Stonewater 48

RE: Stonewater 48 – Residential Amenity Compliance

APPLICANT'S BRIEF REGARDING ENCLOSURE OF EXISTING IRRIGATION DITCH

From: [David Glancey](#)
To: [Hanna Veal](#)
Subject: SUBFY2026 - 0003 - Stonewater 48 Subdivision Response
Date: Friday, October 9, 2026 5:12:49 PM
Attachments: [A-0.01 Site Plan.pdf](#)
[A-2.04 Building Type 4 Elevations.pdf](#)
[Stonewater Ditch Piped Brief.pdf](#)
[Stonewater Not in Old-Original Town Brief.pdf](#)
[Stonewater 48 – Residential Amenity Compliance.pdf](#)

A-0.01

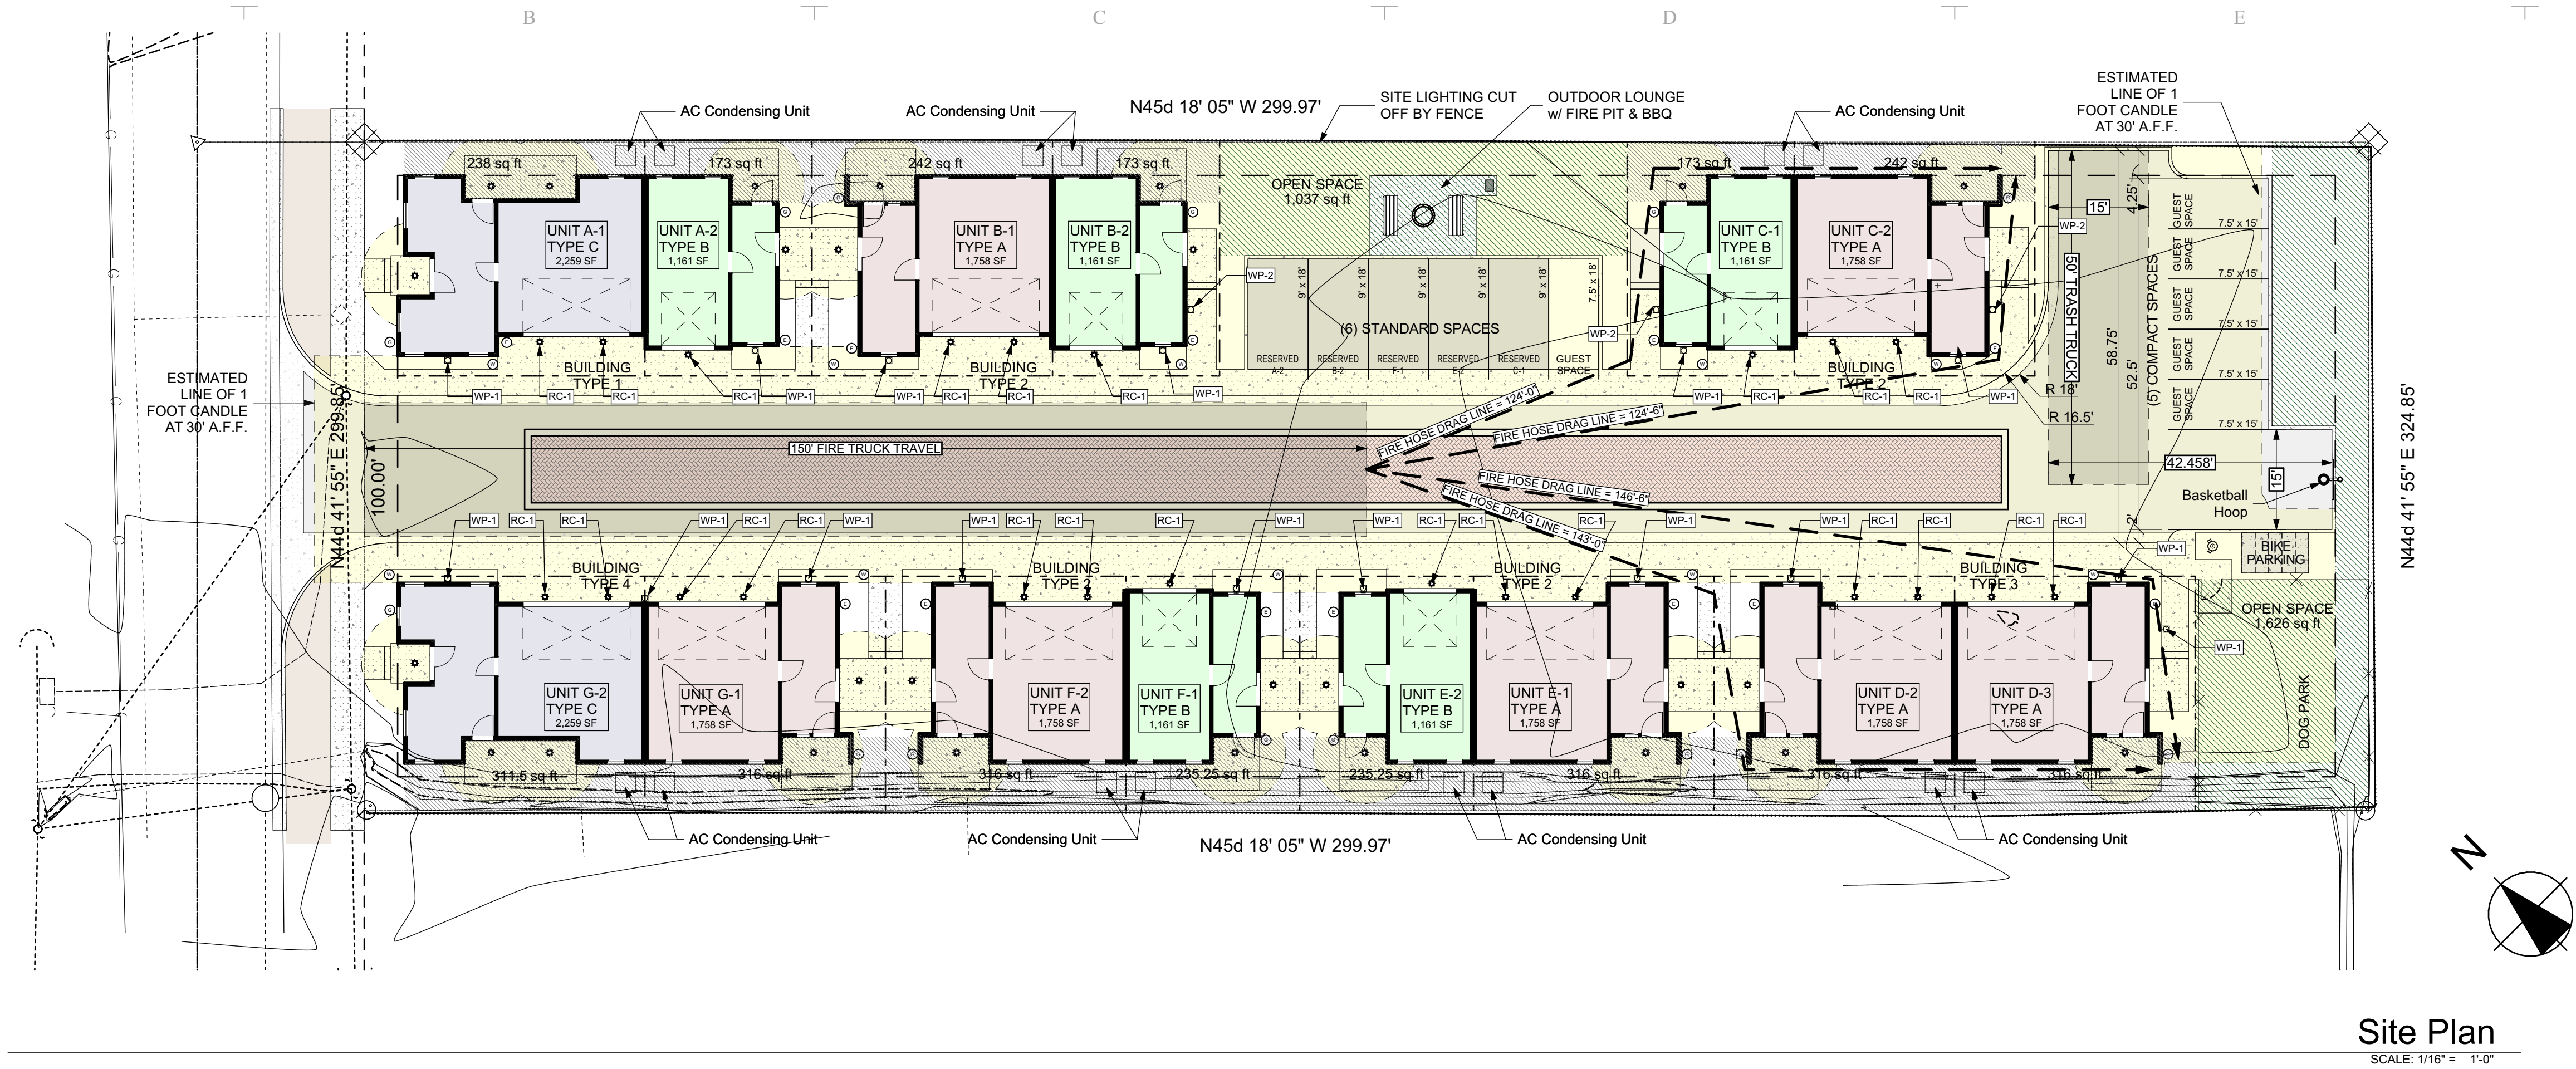
1. Trash Truck Turnaround: Revised the turnaround configuration to address Republic Services' requirements. I walked through a similar layout with Bill over the phone and have provided him with the updated exhibit for review. We are currently awaiting his final confirmation.
2. Fire Access: Added the 150' fire access line along with the corresponding 150' hose drag distance.
3. Residential Amenities: Revised the proposed amenities to address the City's requirements. See the attached Residential Amenity Compliance letter and updated calculations.
4. Open Space: Updated the open space calculations to comply with the new zoning code, including qualifying individual unit open spaces.

A-2.04

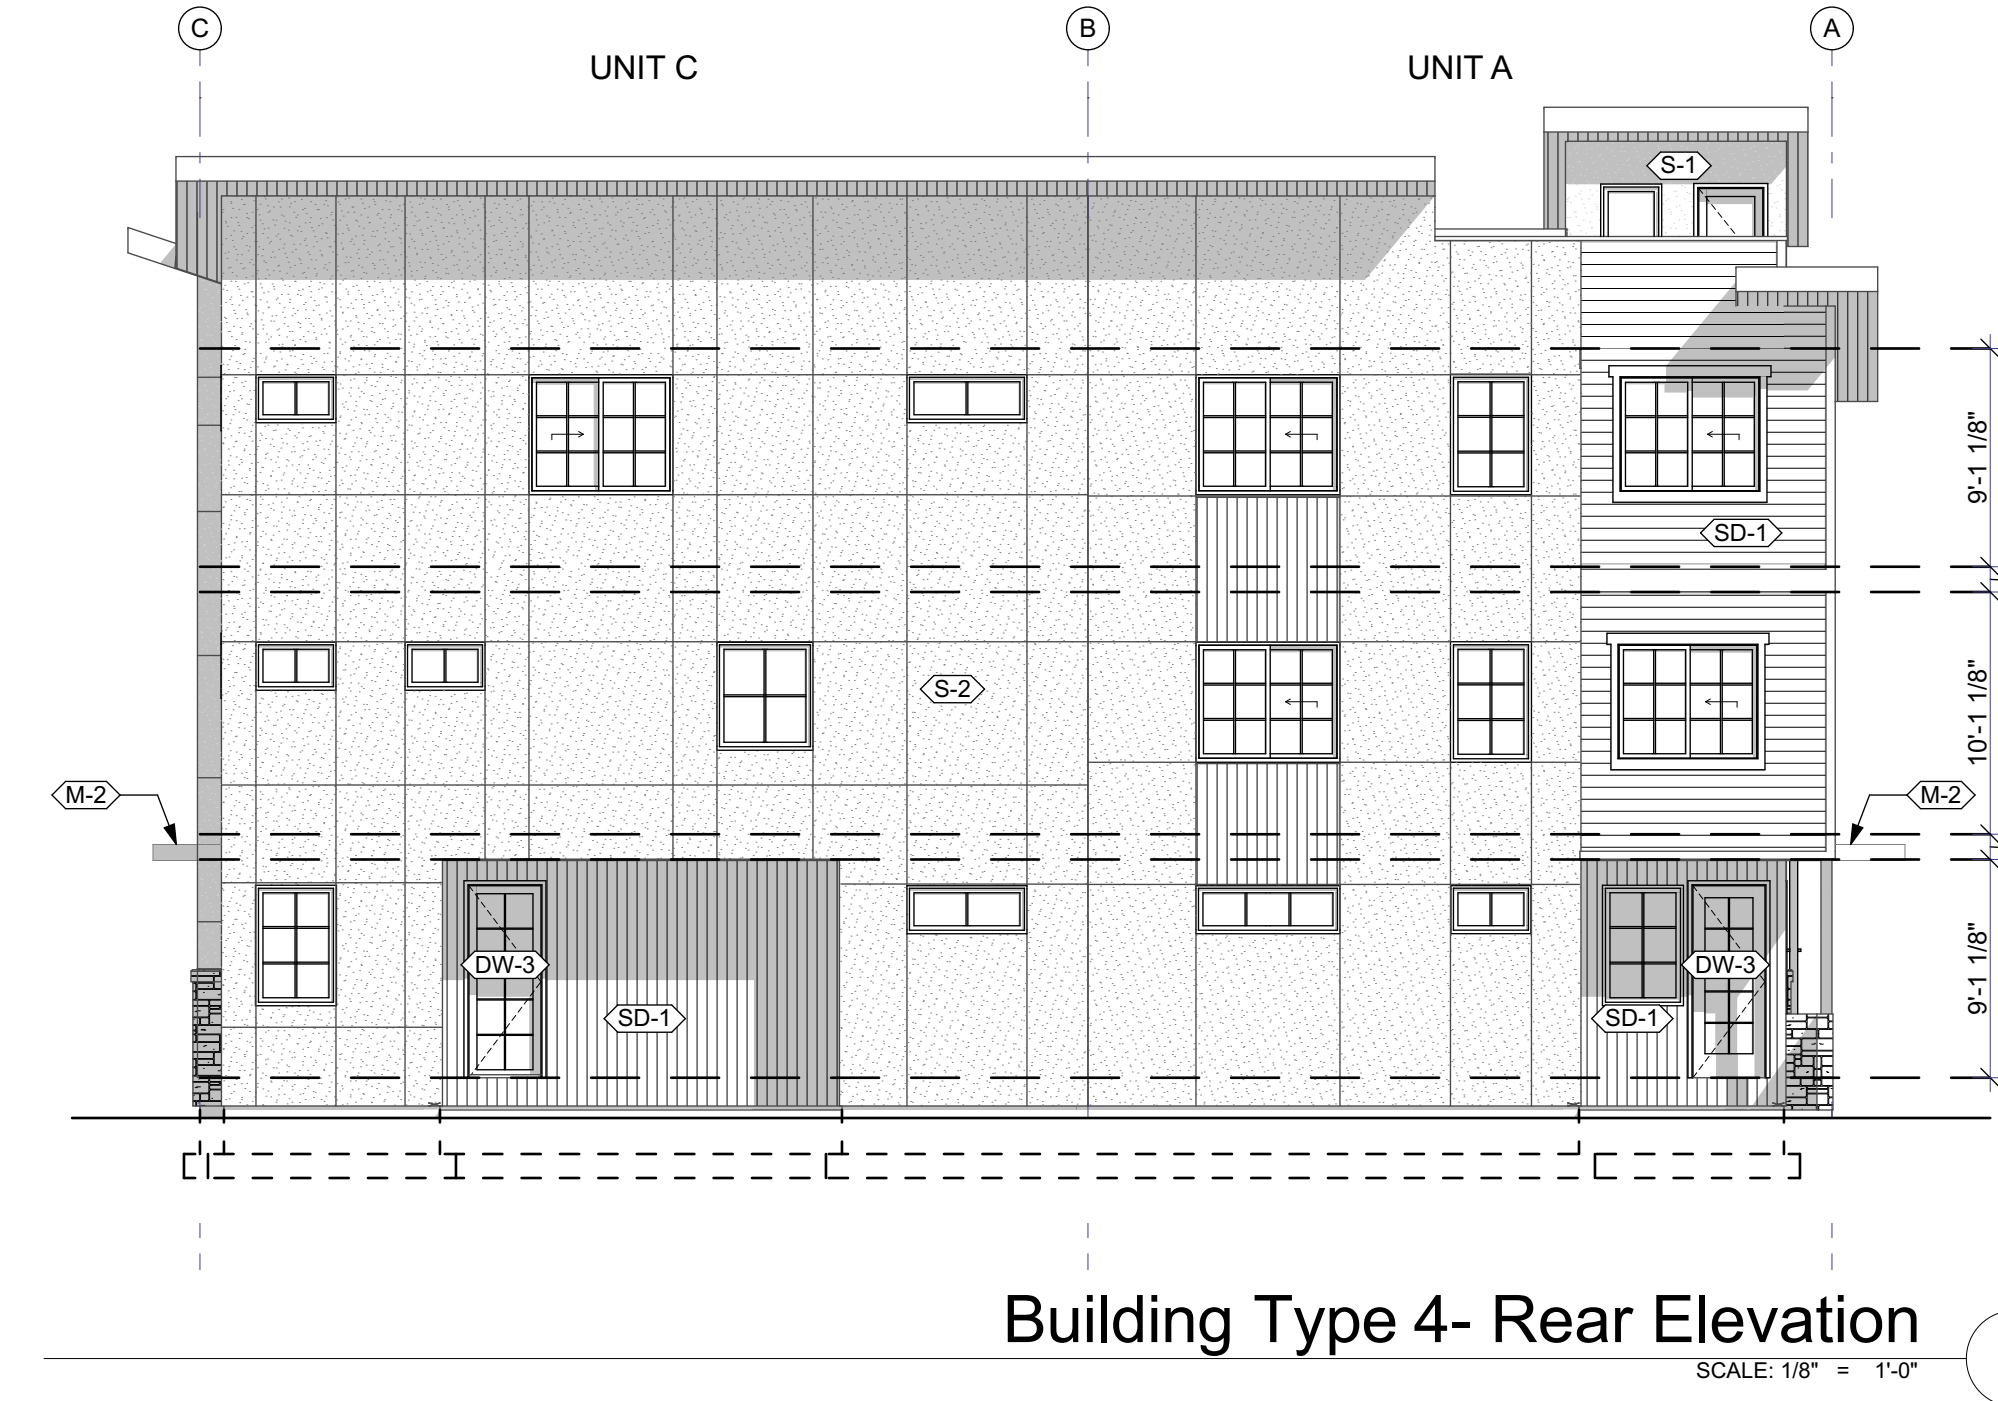
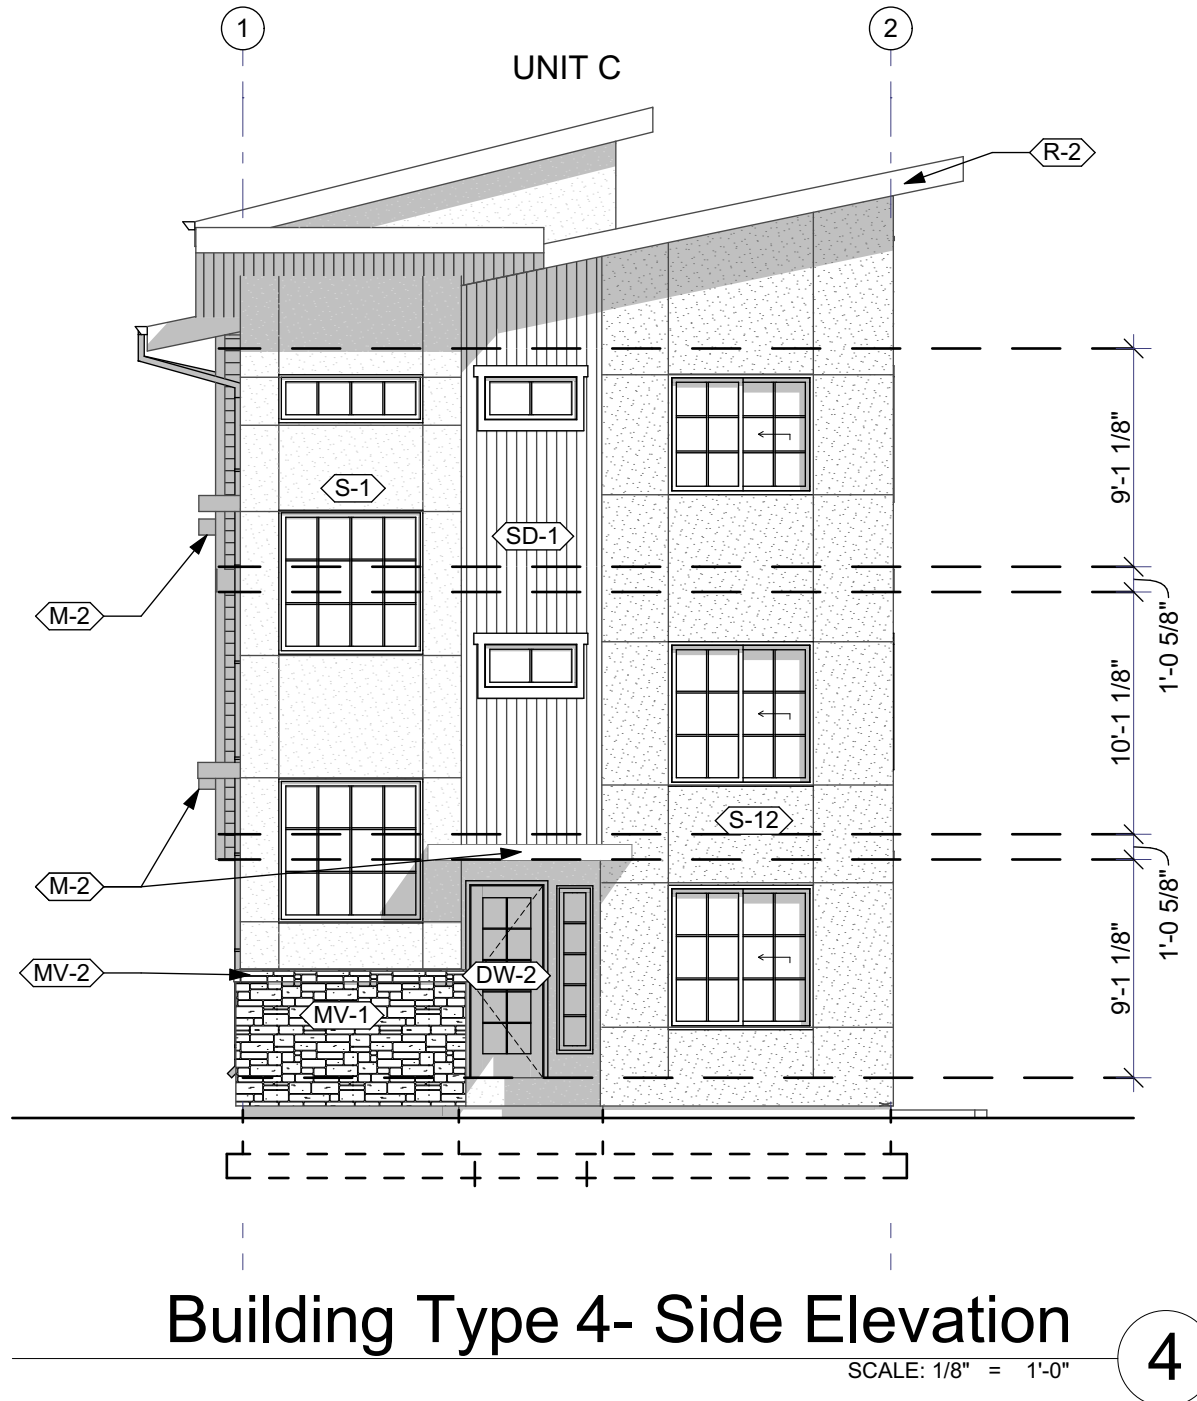
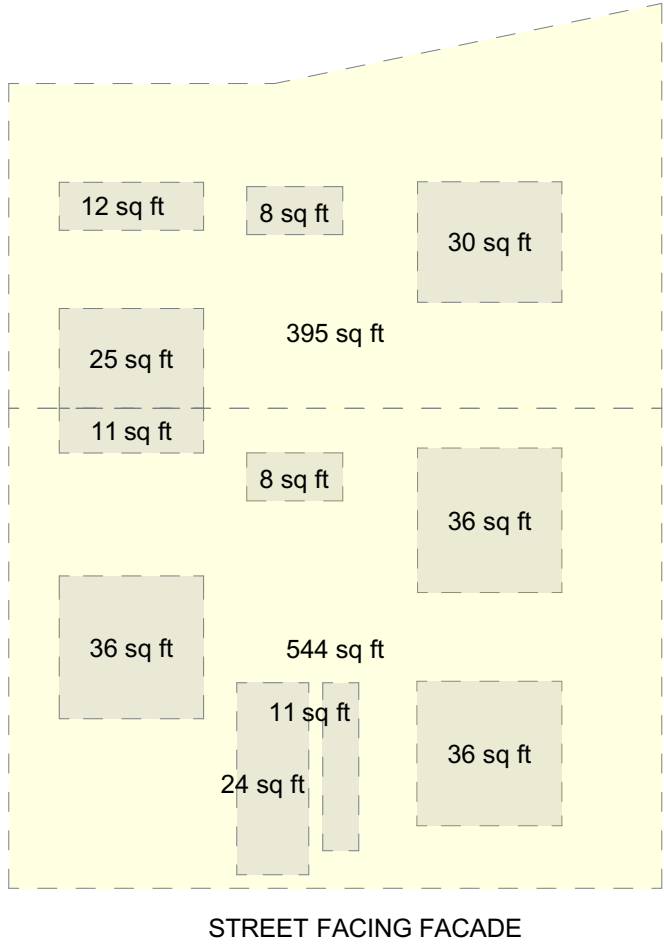
1. Street-Facing Glazing: Revised the façade facing 48th Street to comply with the minimum 30% glazing requirement.

GLAZING AREA:
30*25+12*8=75
UPPER FLOOR FACADE
AREA = 395 SF
GLAZING / FACADE RATIO =
75 / 395 = 18.9%
GLAZING AREA:
36*36+36*24+11*8+11=173
1ST FLOOR FACADE AREA
TO 20' = 544 SF
GLAZING / FACADE RATIO =
173 / 544 = 31.8%
